M084.2 GROUND FAULT CIRCUIT INTERRUPTER

Revised 3/12/08

Models Affected: All Dixie-Narco Models beginning 4/10/07.

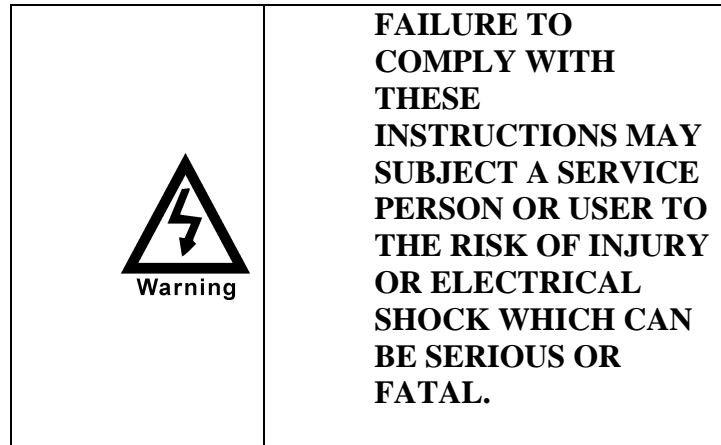
Plug mount GFCI cords are installed in all venders in production beginning April 10, 2007. Below is a list of GFCI cords available for Dixie Narco manufactured equipment.

80492649xx1 - Power Cord GFCI 134", in line mount – beginning serial number 7803-0012CF.

80492512xx1 - Power Cord GFCI 134", plug mount – beginning 7773-0147 to 7803-0012CF.

Includes 7770-0001 through 0120. Plug mount GFCI are no longer available.

80492651xx1 - Power Cord GFCI 156", in line mount – beginning serial number 8599-0001CF.

80492513xx1 - Power Cord GFCI 156", plug mount – beginning 8570-0077 to 8599-0001CF. Plug mount GFCI are no longer available.
